## **Planning Commission Staff Report: Site Plan Application STP2013-00146, 201 West Gude Drive**

**MEETING DATE:** February 27, 2013

**APPLICATION DESCRIPTION:** Proposes to place an award winning "green" development house and a solar vehicle charging station on the property for educational purposes. To support expected tours, a 700 square foot laboratory/restroom building is also proposed.

RE: PEPCO Service Center Watershed Building, 201 West Gude Drive  
Pre-application and Development Stormwater Management Concept Approval  
SMP2013-00007

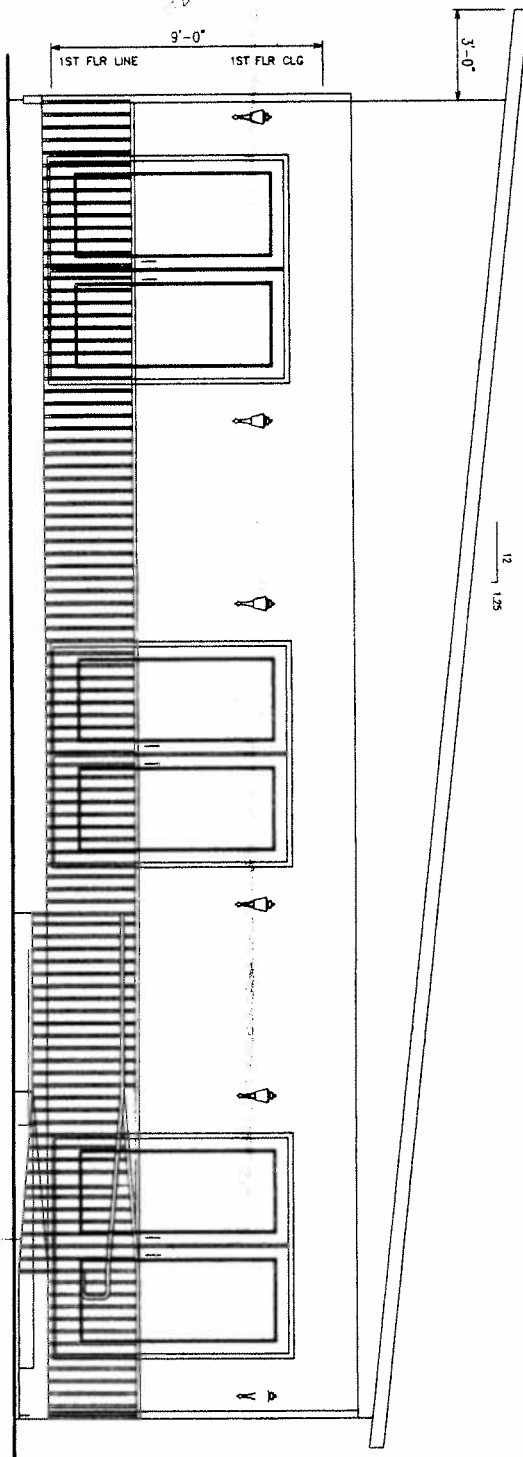
1. Submission, for approval of the Chief of Planning, of twelve (12) copies of the site plan (on sheets no larger than 24 inches by 36 inches) altered to include the following:
  - a) Correctly depict the proposed buildings and include dimensions of the buildings;
  - b) Adjustment of the bus lane to accommodate the functional movements of a school bus;
  - c) Adjacent to the bus lane, shift the lead walk to a location that matches the expected location of the door of the bus.
  - d) Correctly depict the relocated handicapped parking spaces
2. Submission, for approval of the Chief of Planning, of nine (9) copies of the architectural plans (on sheets no larger than 24 inches by 36 inches).
3. Submission, for the approval of the Chief of Planning, of nine (9) copies of a coordinated detailed landscaping plan (on sheets no larger than 24 inches by 36 inches).
